**CITY OF BATON ROUGE
PARISH OF EAST BATON ROUGE**

ADDENDUM NO. 2

**RUNWAY 13/31 SAFETY AREA AND RPZ RUNWAY IMPROVEMENTS
LA HWY. 67 / PLANK RD. PHASE I**

The following revisions shall be incorporated in and take precedence over any conflicting part of the original Contract Documents.

SHEET NUMBER	02a
EAST BATON ROUGE	BATON ROUGE, LA
PARISH	CITY
PROJECT	3-22-0006-110-2018
DESIGNED	ANB
CHECKED	MAK
DATE	MAY 2020
SHEET	3 OF 3
REVISION DESCRIPTION	APPENDIX 2
DATE	6-22-2020
NO.	1
BY	ANB
TYPICAL SECTIONS AND DETAILS	
RUNWAY 13-31 SAFETY AREA RPZ IMPROVEMENTS

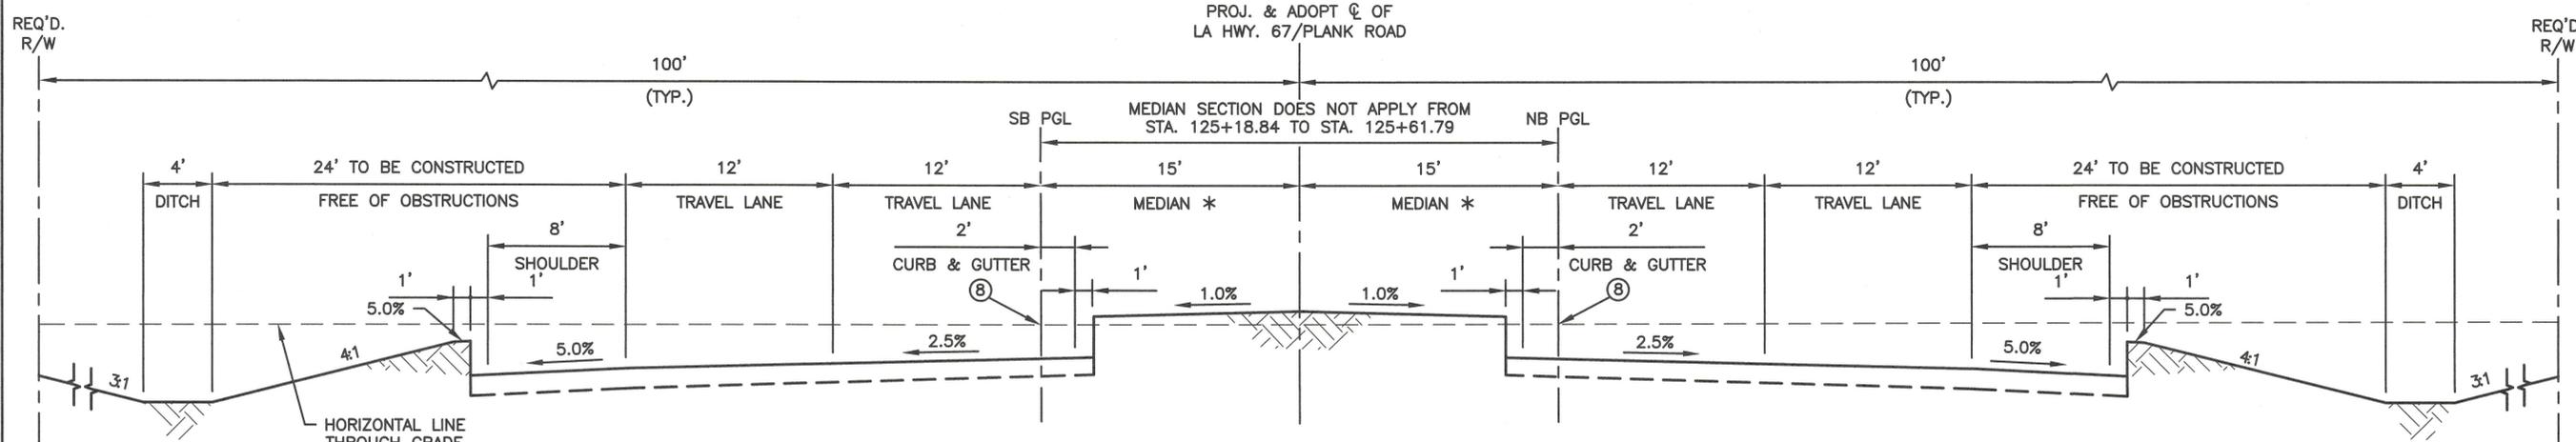
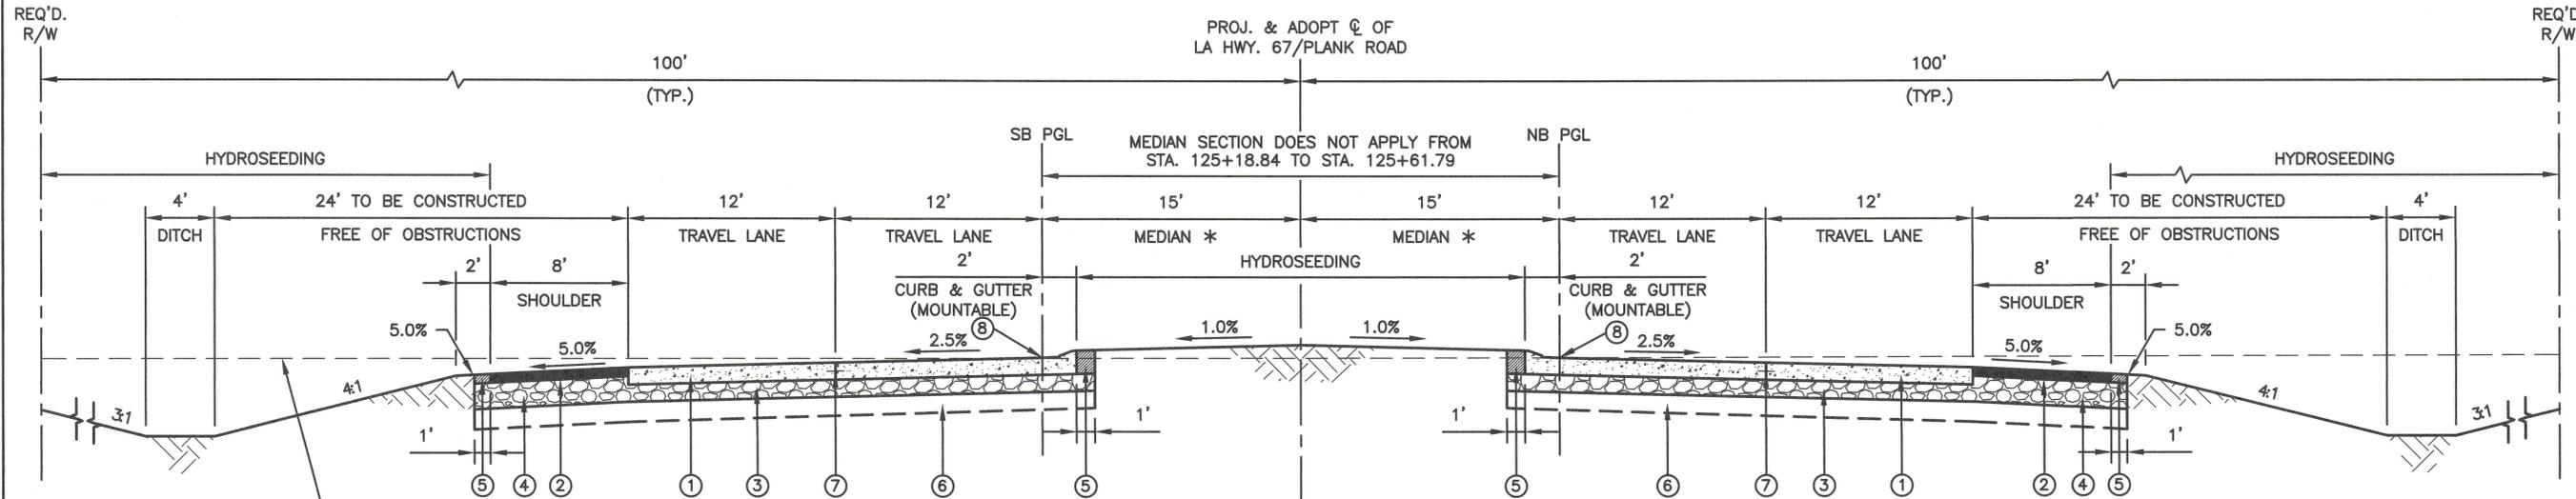
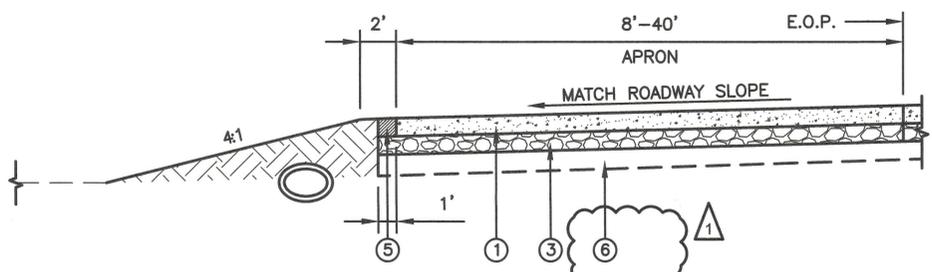
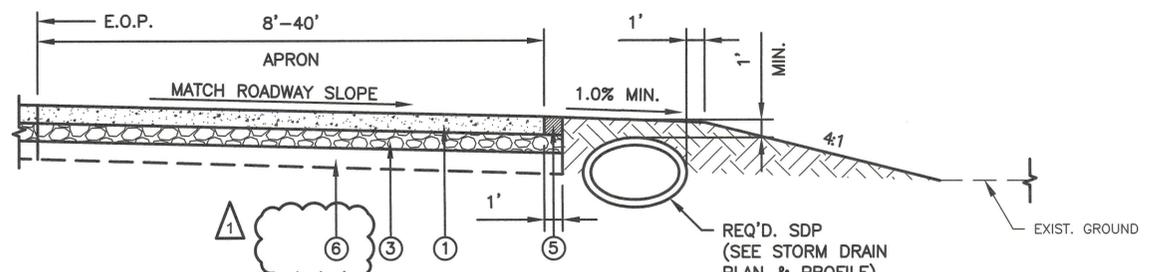
Replace Sheets numbered. 01, 02a, 03, 03a, 04, 40, and 202, with attached revised sheets 01,02a,03, 03a, 04, 40, and 202, dated June 22, 2020.

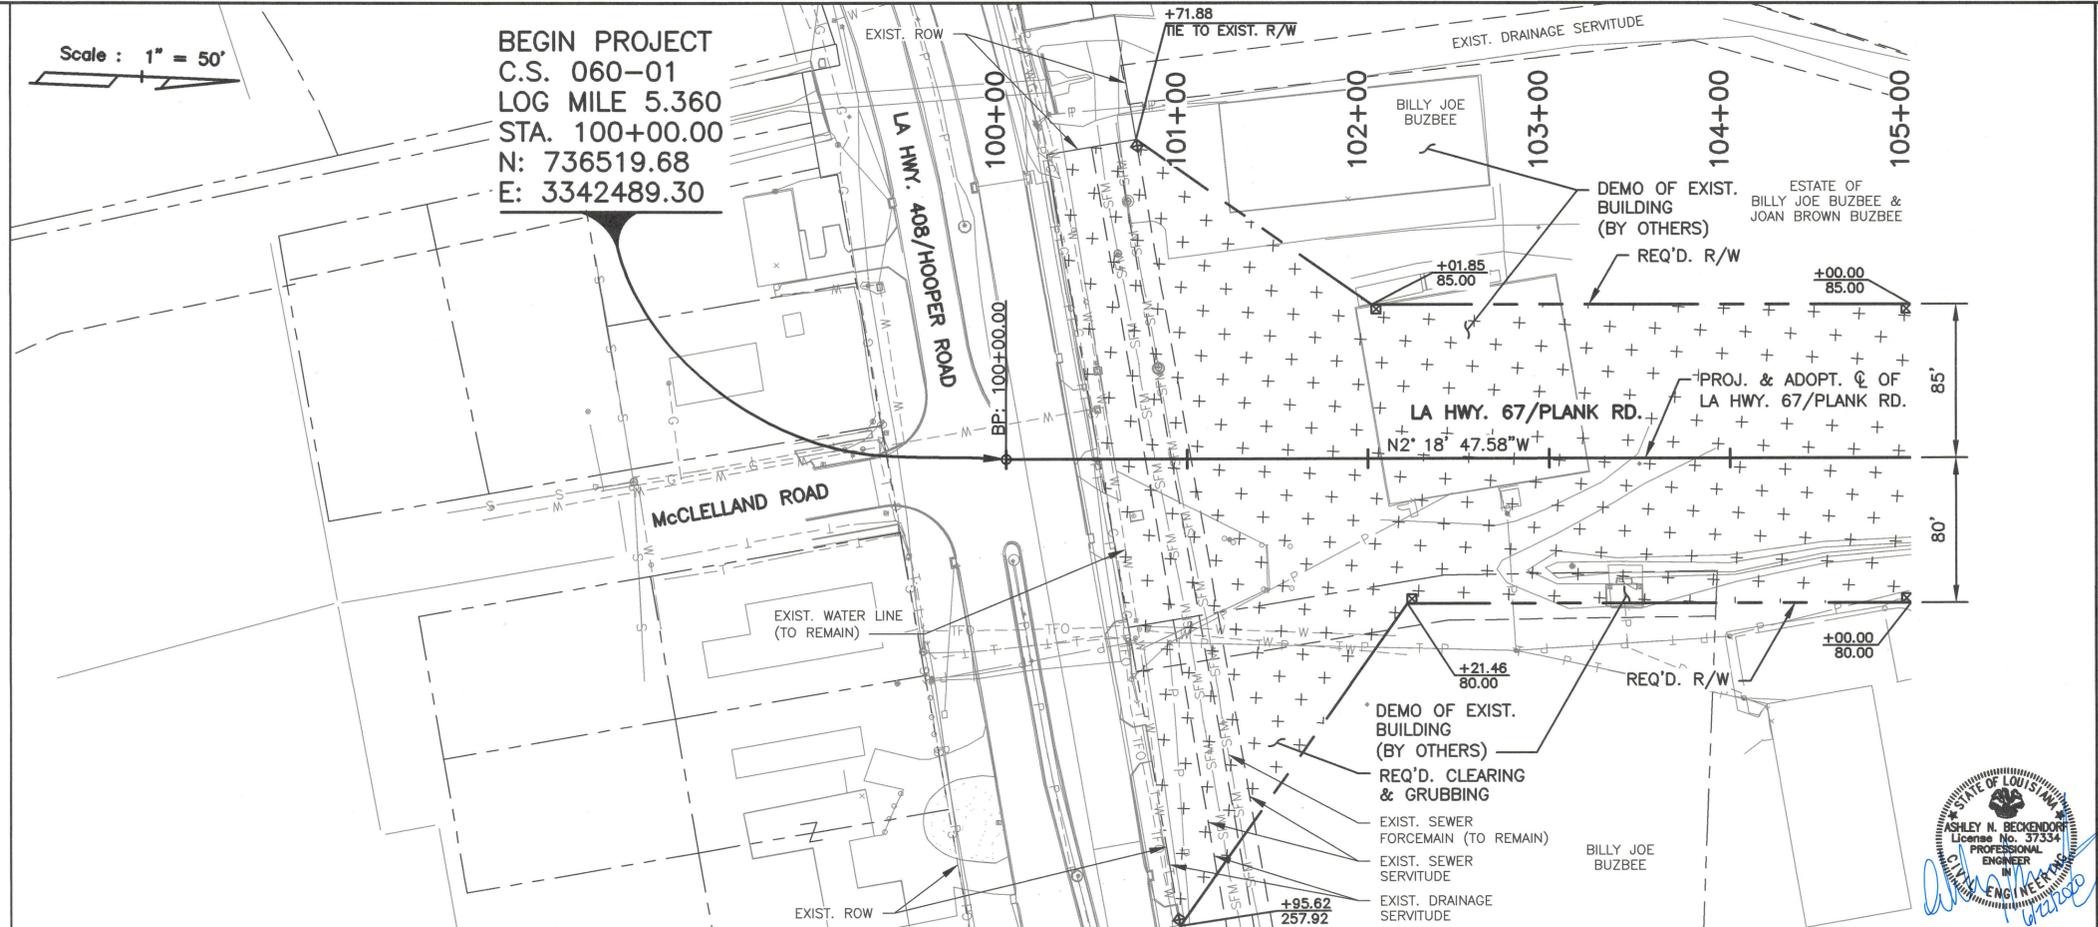
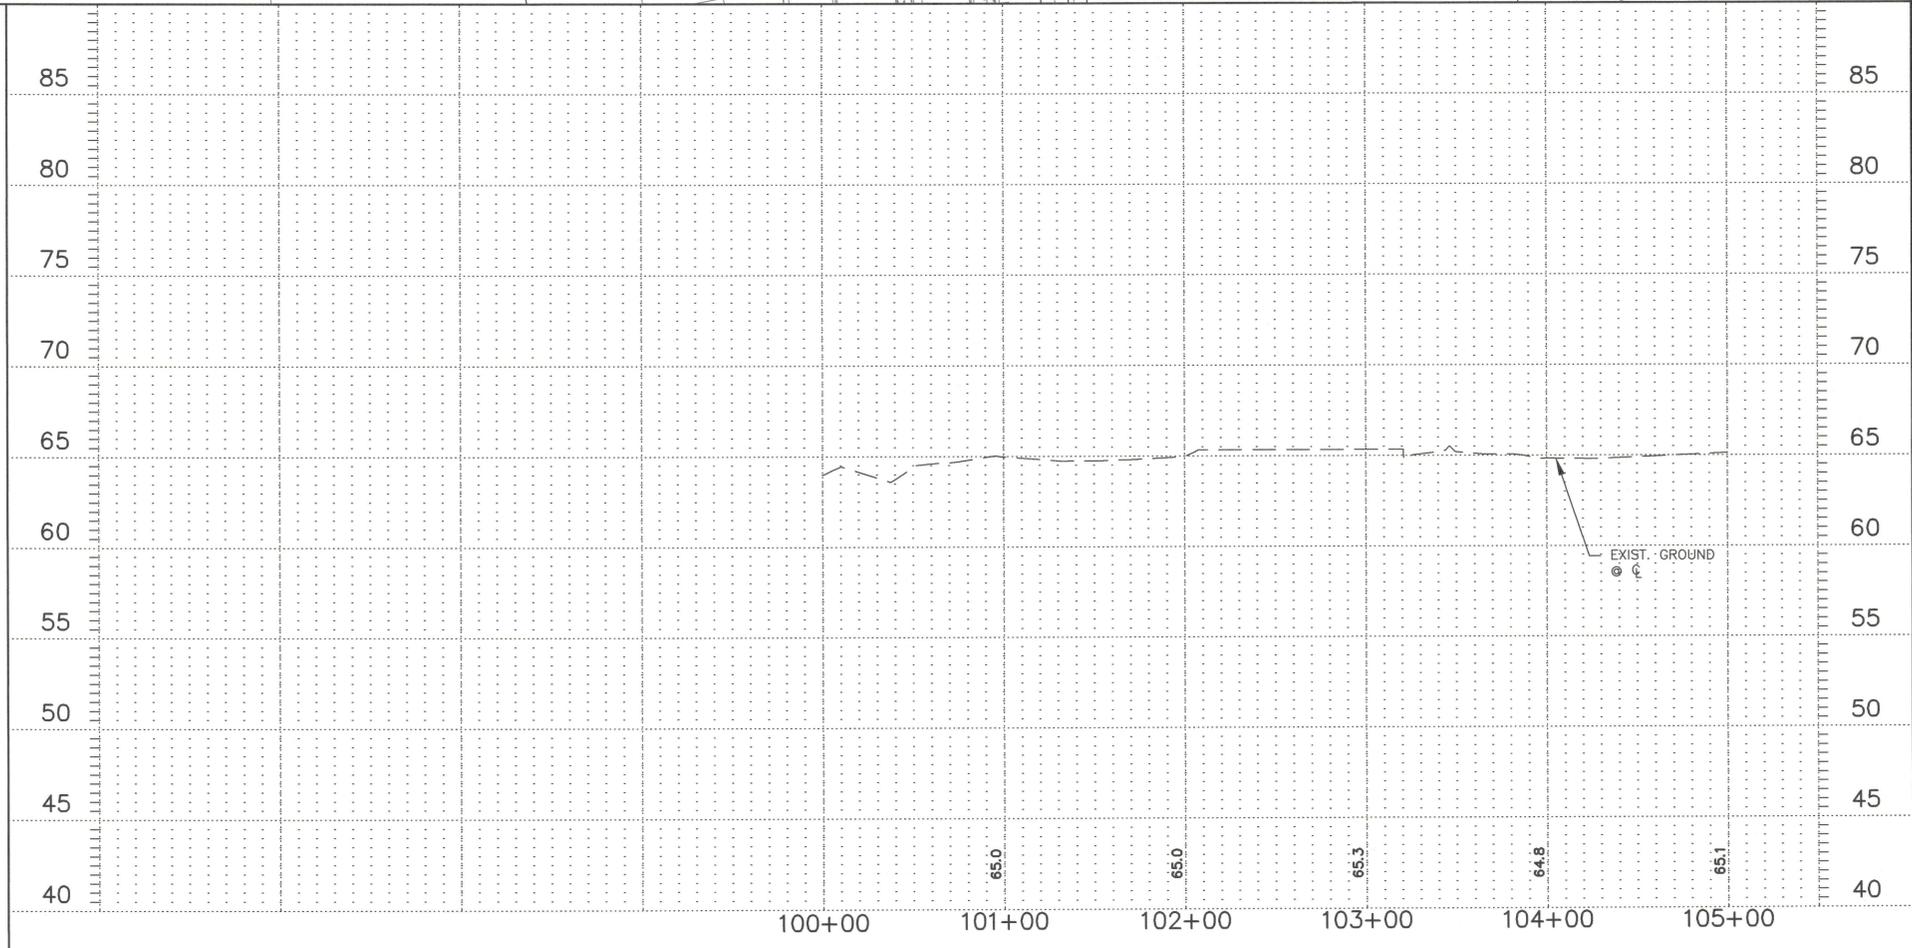
- Q5. Plan sheet 04 shows clearing and grubbing from Sta. 100+00-107+00 and sheet 06 from Sta 126+30-131+00, no clearing and grubbing is shown from Sta. 107+00-126+30. Please clarify that clearing and grubbing will be for the full length of the project, Sta 100+00-131+00 and from right-of-way line to right-of-way line.

- A5. *The entire project is to be cleared and grubbed. Refer to note 3 of revised Sheet 04 attached.*
- Q6. Will roadway require profilograph? If so what design speed and average index will be used?

- UTILITY RELOCATIONS BY OTHERS.
- SEE SHEET 15 FOR GEOMETRIC LAYOUT AND REFERENCE TIES.
- CLEARING AND GRUBBING TO BE COMPLETED FROM STA. 100+51.40 TO STA. 134+41, FROM EXISTING HOOPER ROAD RIGHT-OF-WAY TO EXISTING PLANK ROAD RIGHT-OF-WAY.
